May 2, 2024

RE: Correction to Site Plan #24-010261

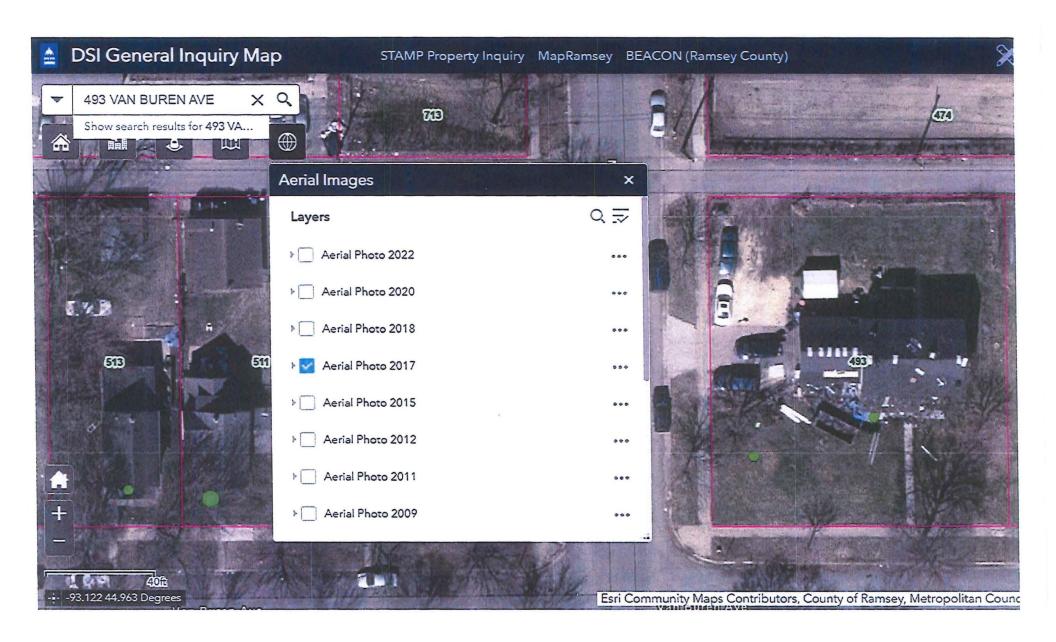
Upon further review, it has come to our attention that there was an error in the description of the yellow highlighted area on the site plan. As per the initial plan, the area highlighted in yellow was indicated as existing gravel. However, upon closer examination of the 2017 aerial image from the City's General Inquiry Map (attached for your reference), it has been observed that part of the yellow highlighted area was covered in grass, not gravel as previously stated. Accordingly, the City is rescinding its approval of the above referenced site plan.

You may submit a revised site plan, accurately delineating the existing gravel area on the lot based on the 2017 aerial image provided by the city. We apologize for any inconvenience this may cause, but it is essential to ensure accuracy and compliance with regulations.
